SUNDRY NOTICES AND REPORTS ON WELLS
**Do not use this form for proposals to drill or to re-enter an
abandoned well. Use Form 3160-3 (APD) for such proposals.**

8. Well Name and No.
Southeast Lusk 34 Federal (308904)

9. API Well No.
30-025-36439

**Southeast Lusk 34 Federal 1
30-025-36439
Apache Corporation
January 25, 2014
Conditions of Approval**

Proposed

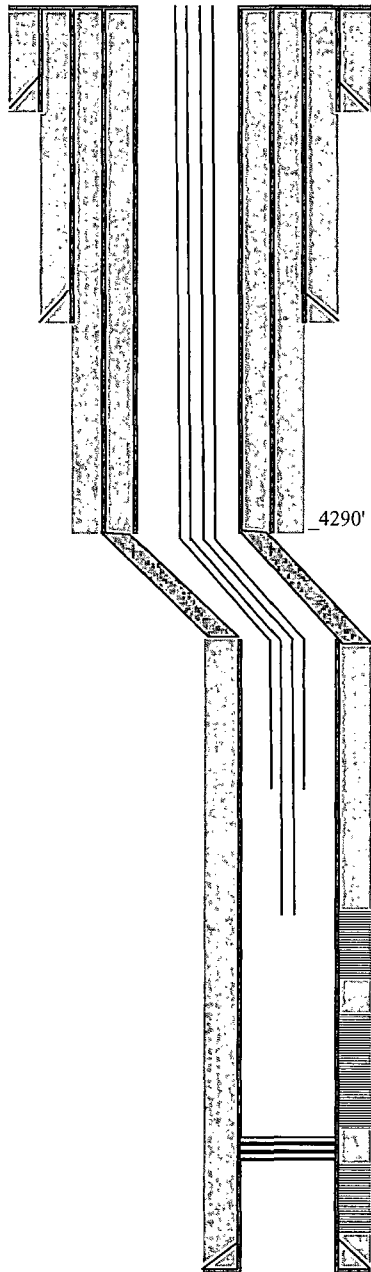
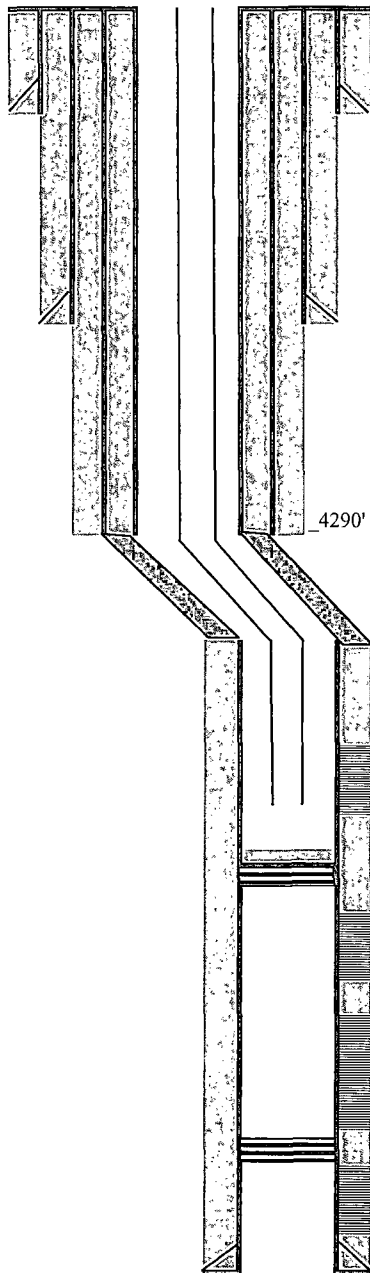
- 1. Operator shall set a CIBP at 12,689' and place 25 sx Class H cement on top. Tag required.**
- 2. Operator shall set a CIBP at 12,254' and place 25 sx Class H cement on top. Tag required.**

- 3. Operator shall set a balanced Class H cement plug from 10,744'-10,539' to seal the Wolfcamp formation.**
- 4. Must conduct a casing integrity test to max treating pressure before any perforating can be done. Submit results to BLM. The CIT is to be performed on the production casing per Onshore Oil and Gas Order 2.III.B.1.h.**
